Turbo HD DVR V3.4.80 Build161217 Release Notes (2016-01-09)

Firmware Version:	V3.4.80 Build161217
	SDK Version:	V5.2.5.15 build20160906
Firmware	Play Library (PlayCtrl.dll)	6.0.0.4
Basic Information	player	7.3.0.0
	Web version	V4.0.1 build161019
	Client version	V2.5.3.8 build20161012

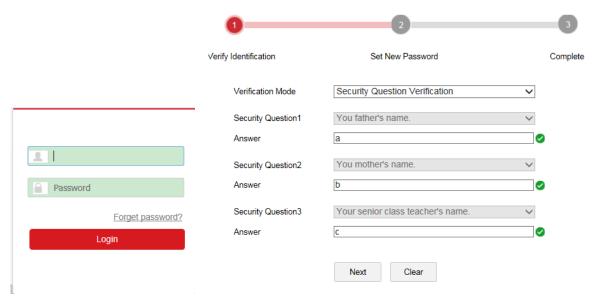
- i. Newly support 5 hybrid signals input: TVI/AHD/CVI/CVBS/IP for 73/76/81/90HUHI-Fx/N series. (for other Turbo 3.0 DVR, it already supported this function on v3.4.70 or v3.4.75)
 - 1) Cancel the principle of signal input type choosing and restriction of channel binding, cameras can be self-adaptive connected to our DVR.
 - 2) Newly support access of 1080P AHD cameras, which used to be 720P AHD cameras.
 - 3) Newly support access of 1080P&720P CVI cameras.
- ii. Newly support password recovery strategy
 - 1) Password recovery on local: Export the GUID file when activating the device or export the GUID file from the *User Management* interface. When forgetting the password, click the Forget Password in the login interface, import the GUID file, and recover the password.

2) Password recovery remotely in the same local area network: Recover the password remotely by answering questions set before, or import the GUID file. Recovering or changing the password wouldn't make questions invalid.

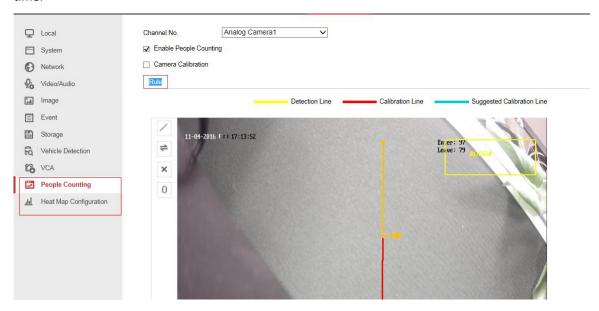
iii. 73&81&90HUHI-Fx/N series newly support one analog channel **People Counting** or **Heat Map** function.

Note: VCA functions (intrusion detection, line crossing detection and sudden scene change), people counting and heat map are mutually exclusive. Only one of these three functions can be supported one time.

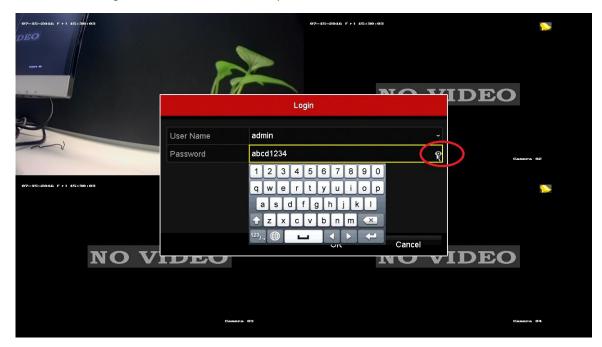
- xi. 73&8104HQHI-F/N newly support 1 channel sudden scene change VCA function. Newly support reverse playback. Newly support 4 channels RTSP playback.
- xii. 7616HUHI-F2/N total bandwidth is changed from 140M to 144M, incoming bandwidth is changed from

72M to 76M.
